Minutes of 9th Meeting

Item 3 Draft Outline Concept Plans for Stage 2 Public Participation [SEKD SC Paper No. 9/05]

Kai Tak Planning Review

*Draft Outline Concept Plans &
Programme for Stage 2 Public Participation*
草擬概念規劃大綱圖及第二階段公眾參與計劃

Concept 1: City in the Park

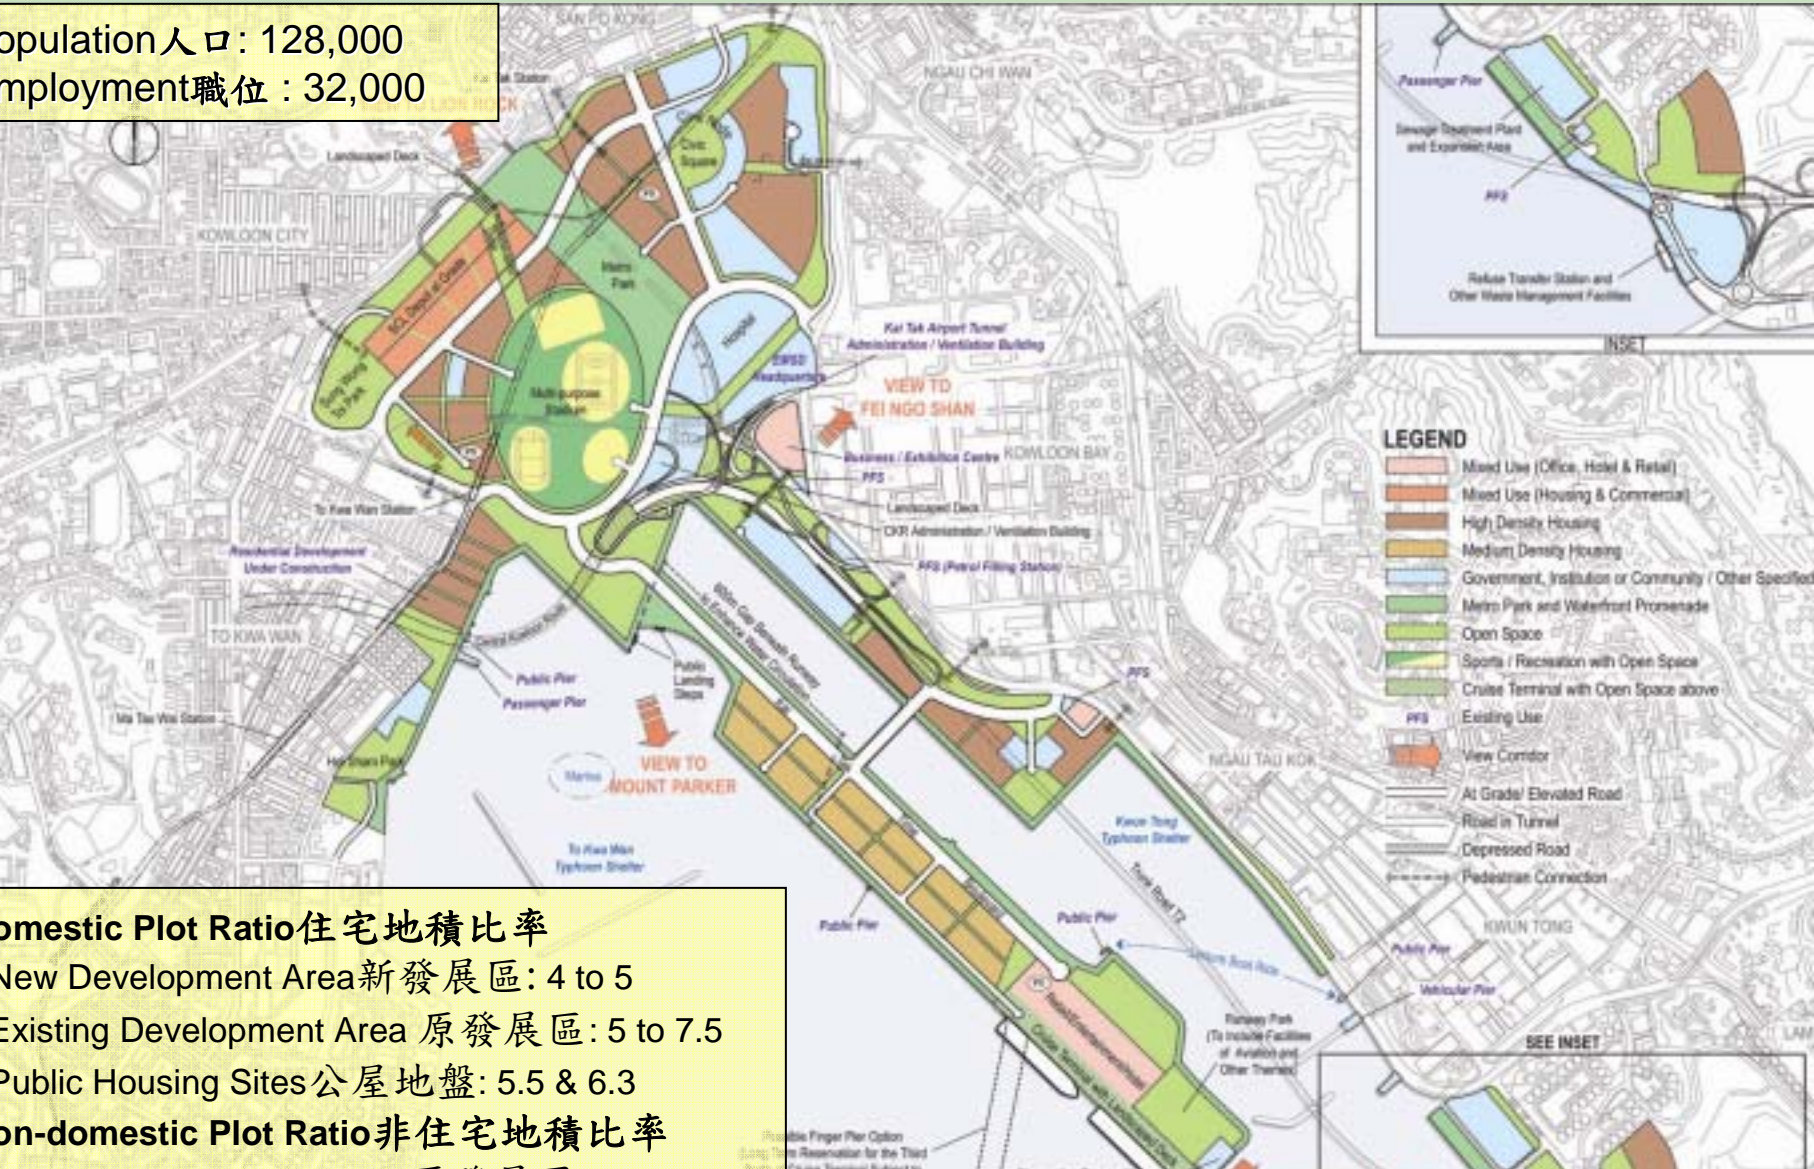
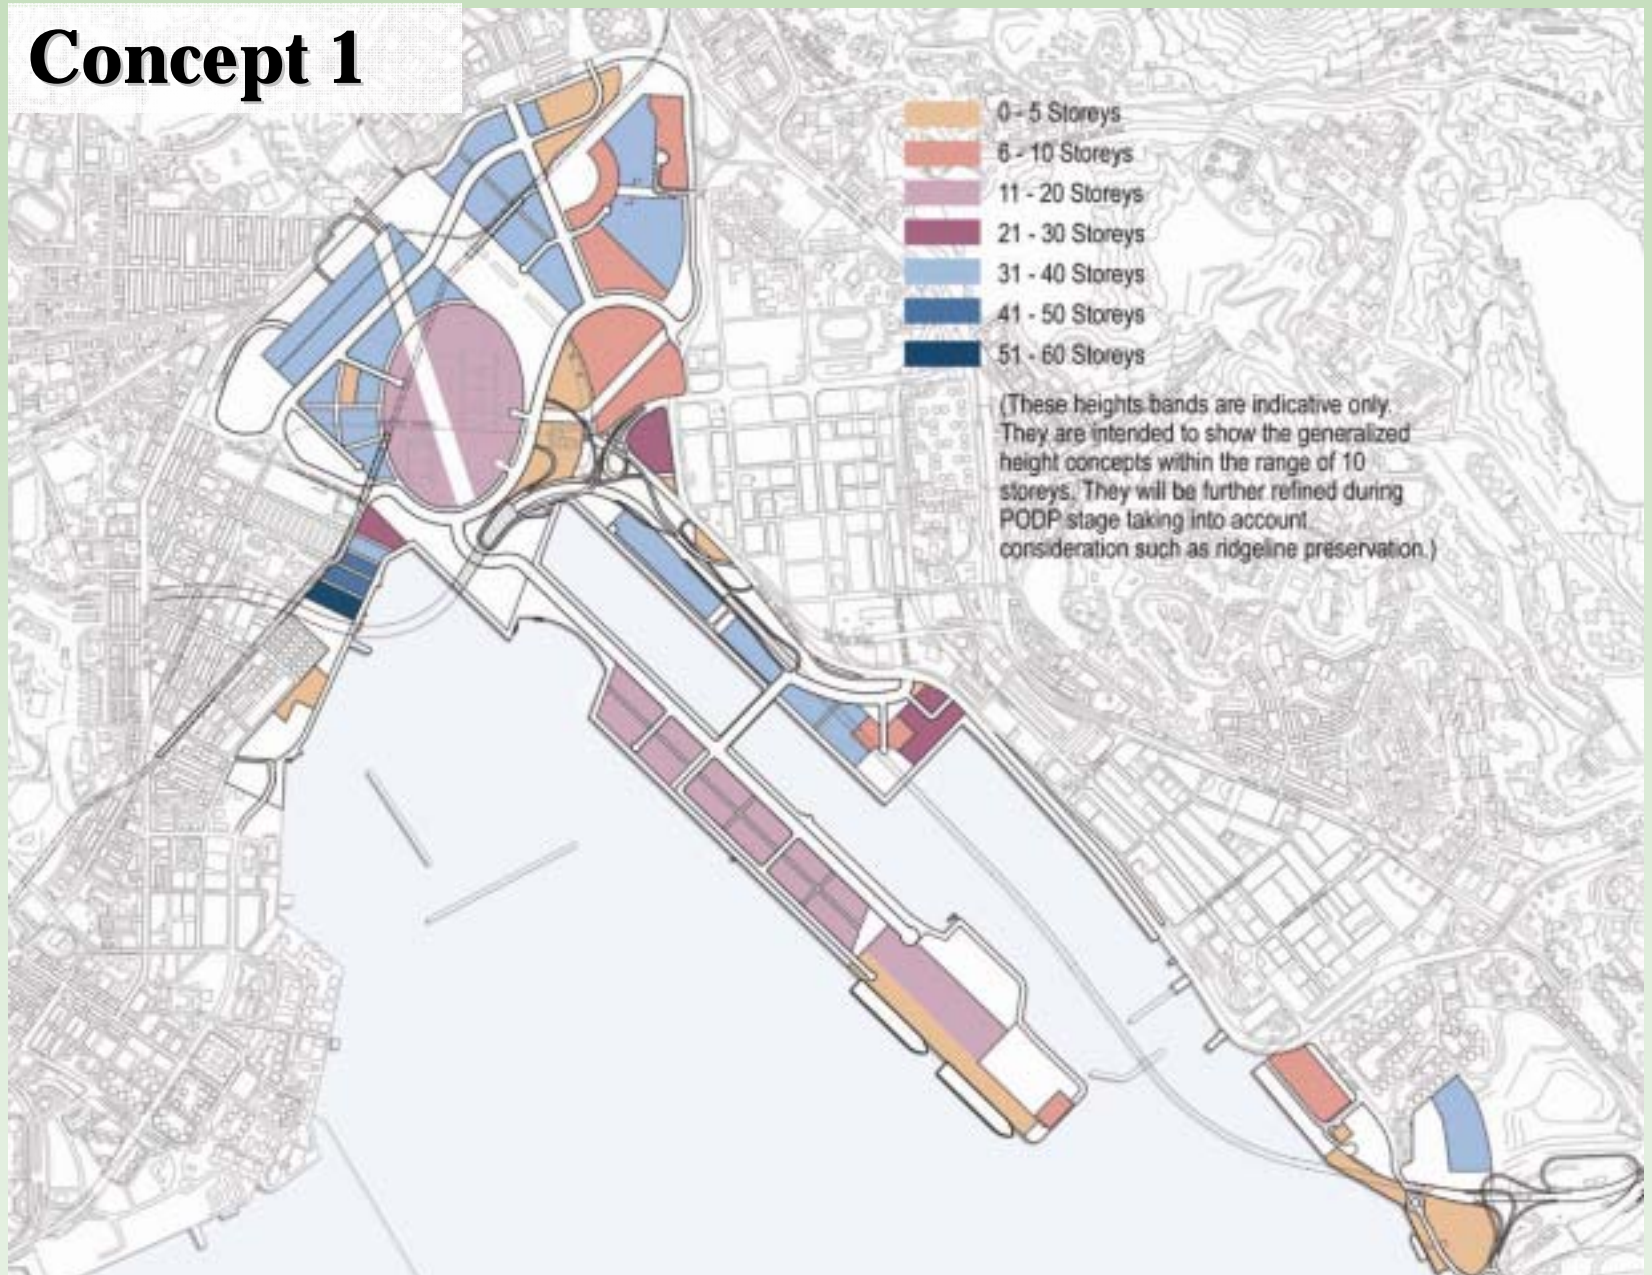
- 3.35 **Professor Lam Kin-che** made the following comments:
- (a) The higher intensity development tended to be located on the western side adjoining the stadium site. He wondered if there could be better spatial arrangement of these developments thus to provide visual relief especially for the stadium users.

- (b) Based on the "no reclamation" approach, the KTAC would be a rather large area of water body, which could provide

- (c) The previous Kai Tak study had proposed to redevelop the Kai Tak site into an environmentally friendly city. The concept plans should aim to redevelop Kai Tak comprehensively to achieve this goal than just to provide an “Environmental Education Metro Park” under OCP3. This would demonstrate Hong Kong’s commitment in achieving environmental and sustainable development.

Concept 2: Kai Tak Glamour

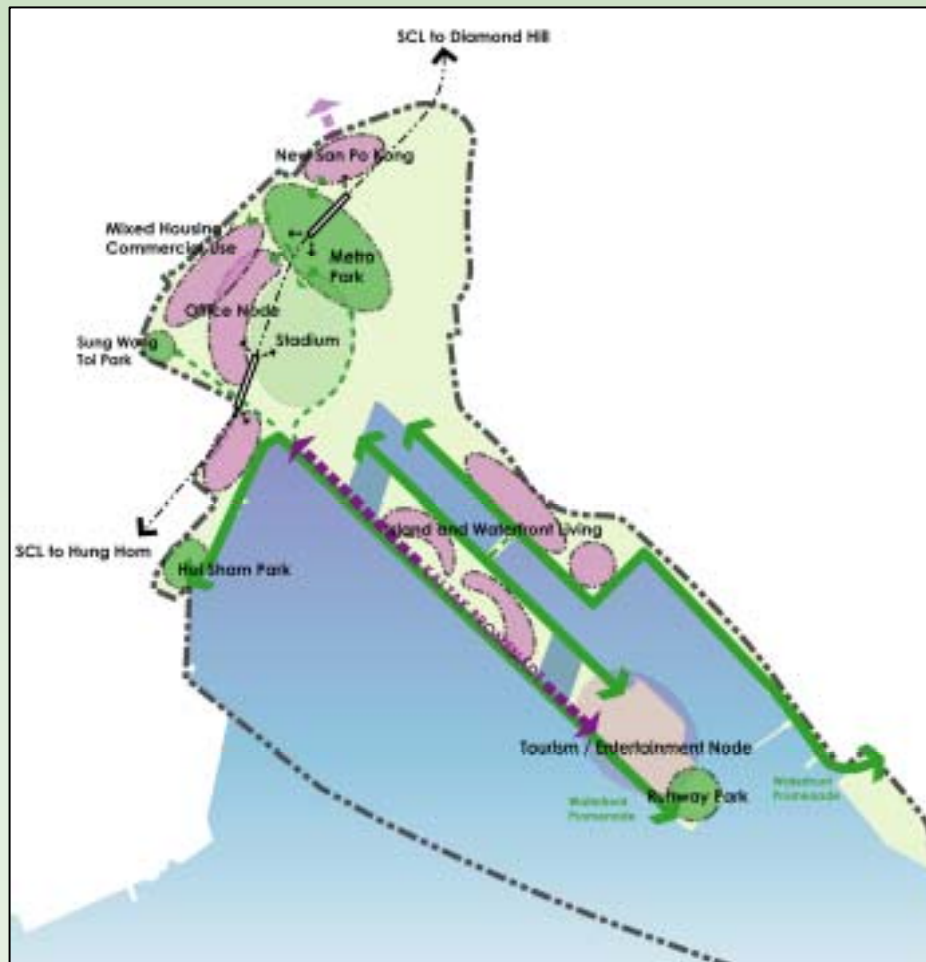
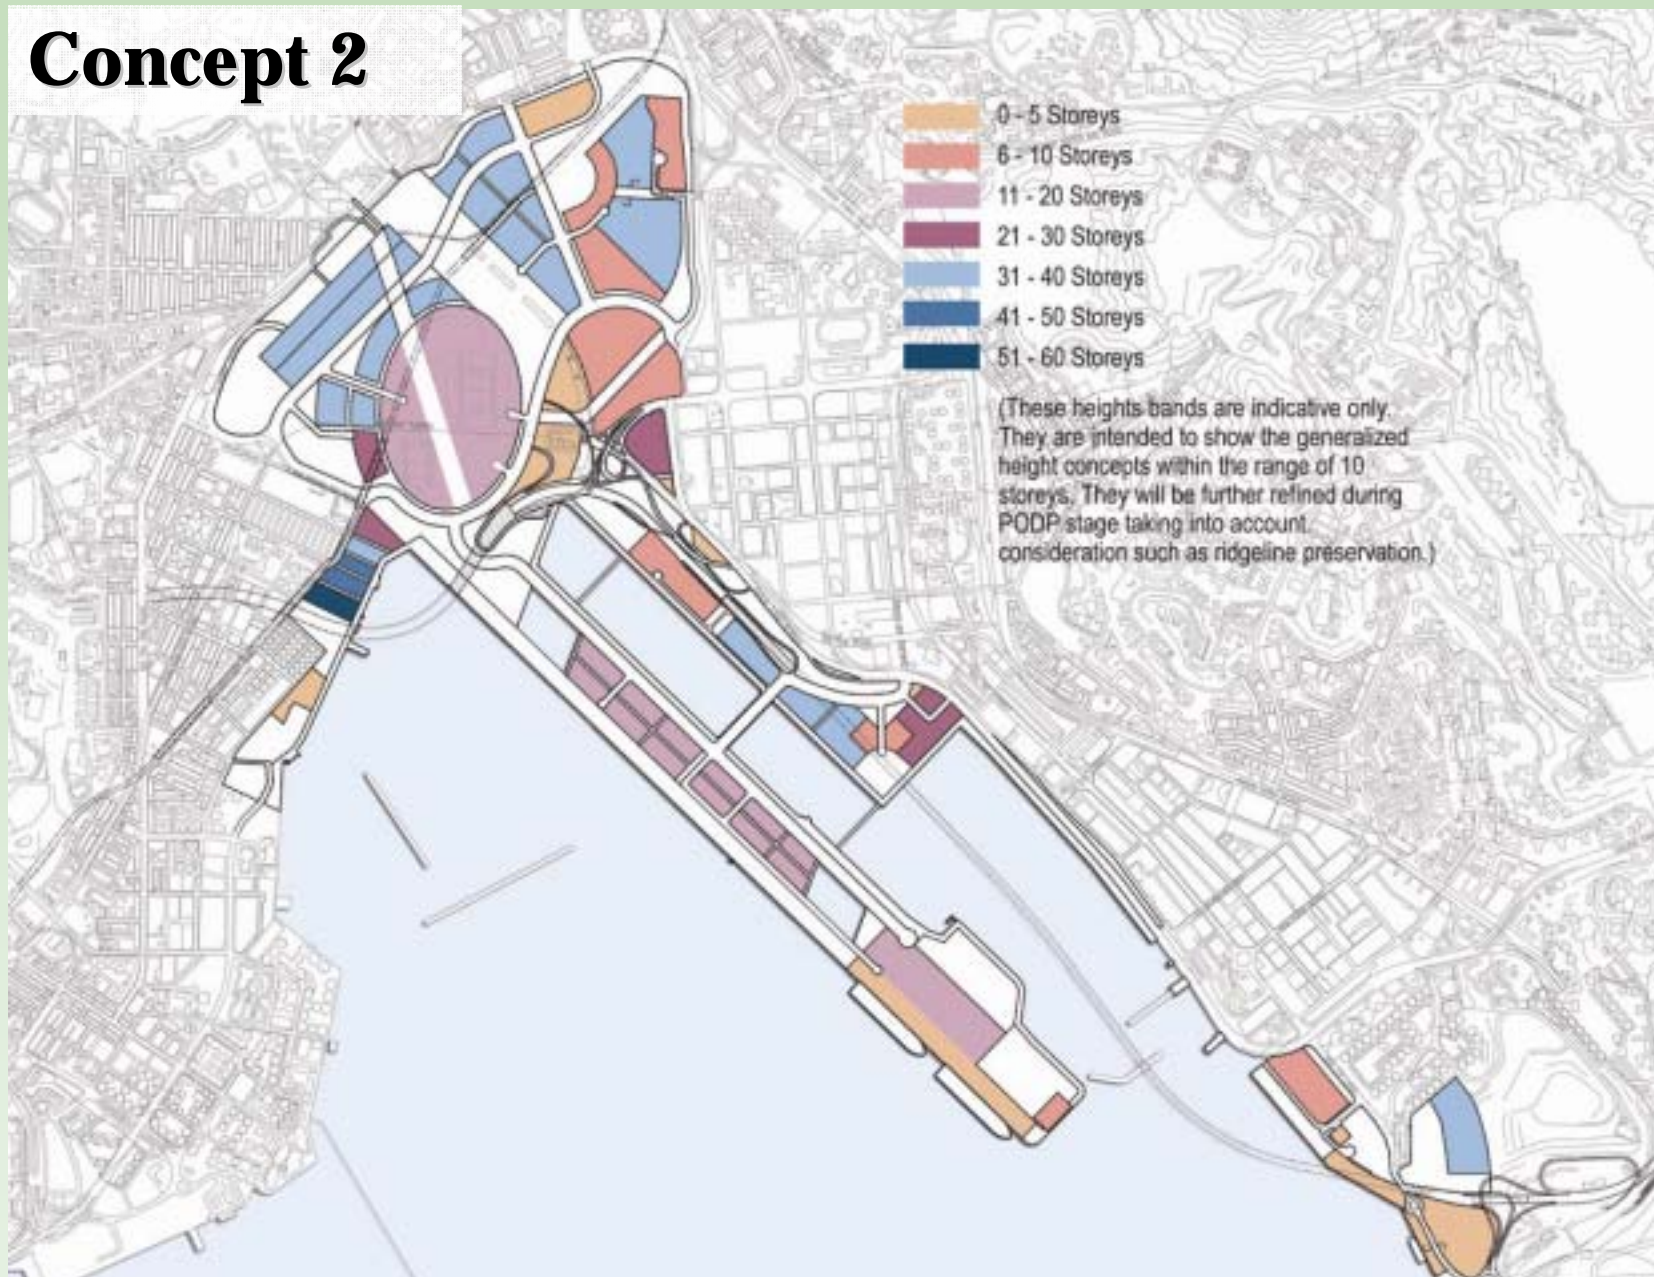
- (a) The highway interchange for CKR and Road T2 would impose major accessibility constraints to the waterfronts area at KTAC and Kowloon Bay. The study could investigate ways to streamline the highway proposal to enhance the accessibility to the surrounding areas.
- (b) The developments in the runway area would rely on road transport. More innovative ideas such as introducing monorail should be investigated to improve connectivity with other districts.
- (c) A bridge to link the Kai Tak cruise terminal site with Kwun Tong should also be investigated to enhance accessibility and better integration.
- (d) The proposal of no development above the railway depot of OCP2 might not be financially feasible.

Concept 3: Sports by the Harbour

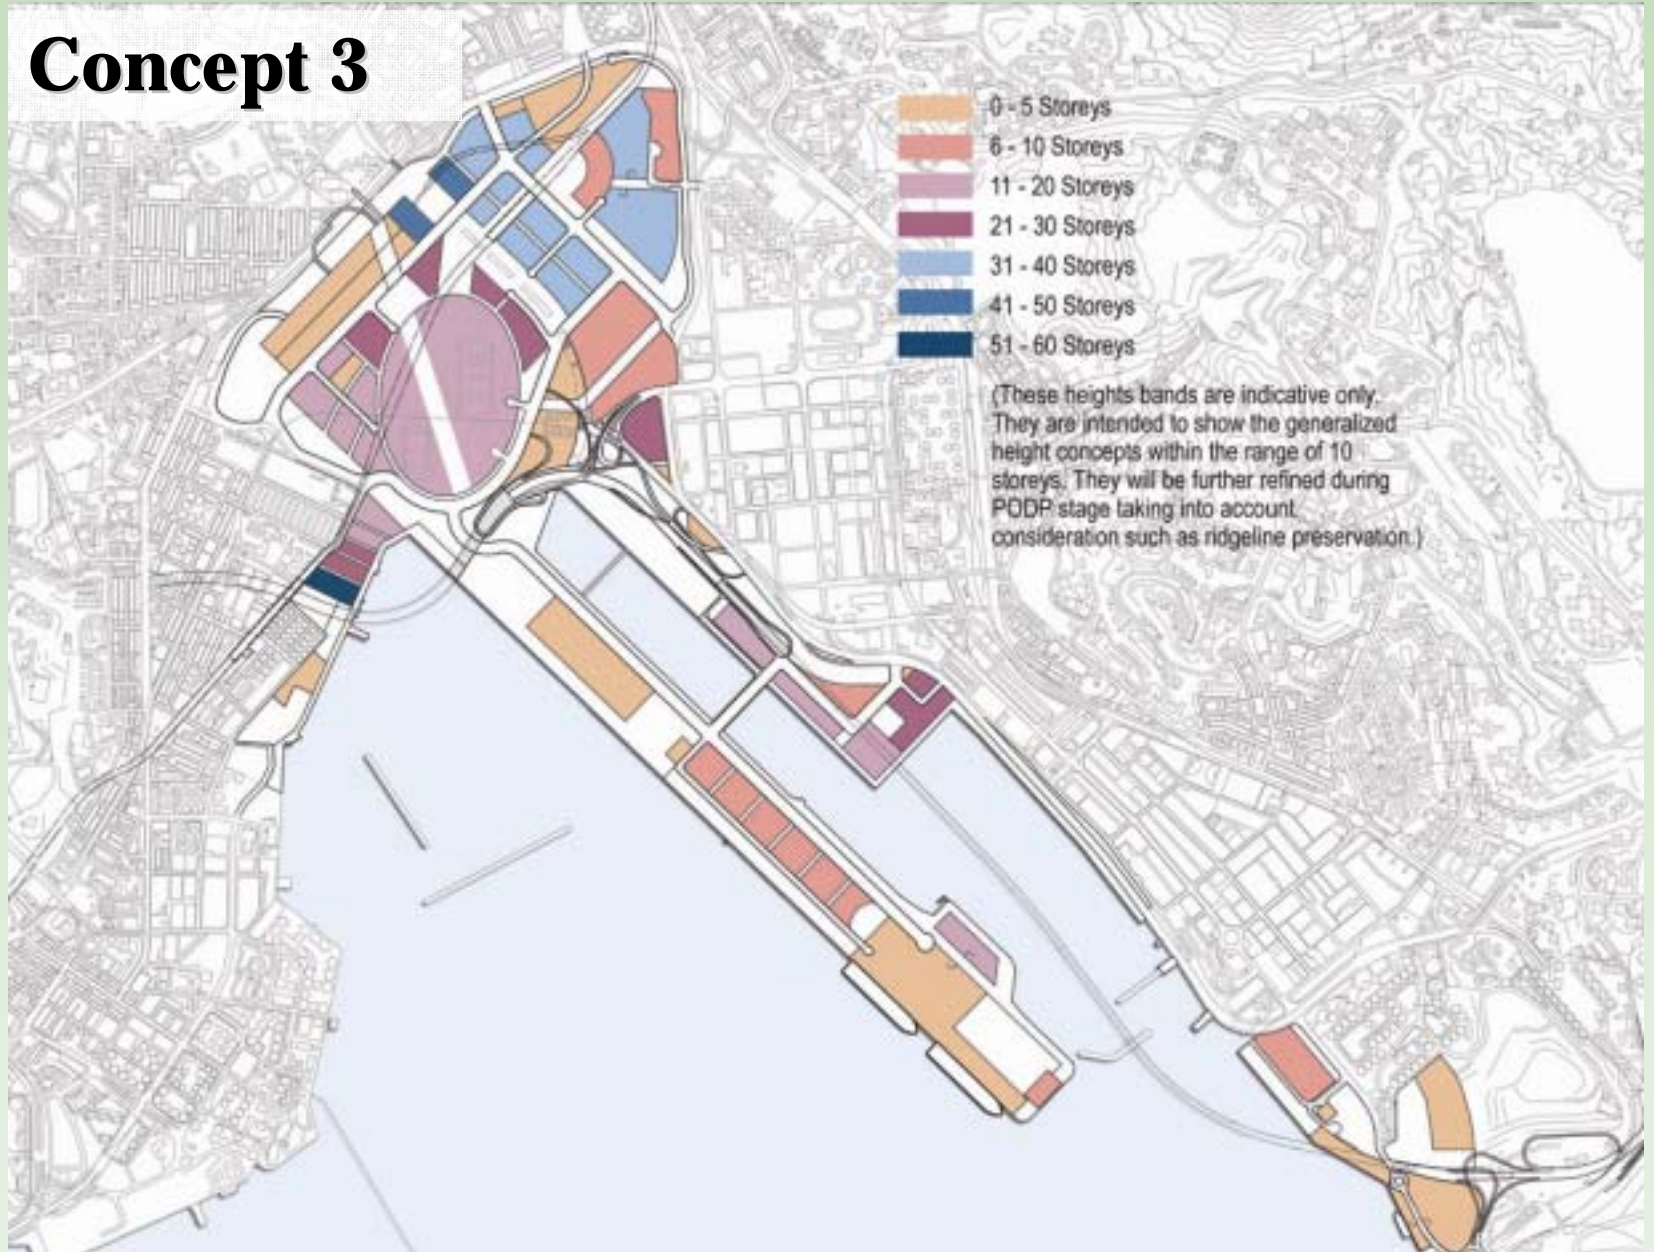
- (a) From the sustainable development perspective and cost vs. value, OCP2 was marginal and OCP3 was not feasible.
- (b) The foundation for the proposed public housing which was already in place could just as easily be converted to private residential use or other uses.
- (c) The major development components such as the cruise terminal and stadium were basically suggestions emanating from the Administration. Other ideas/uses for the stadium and cruise terminal sites from the community should be welcomed.
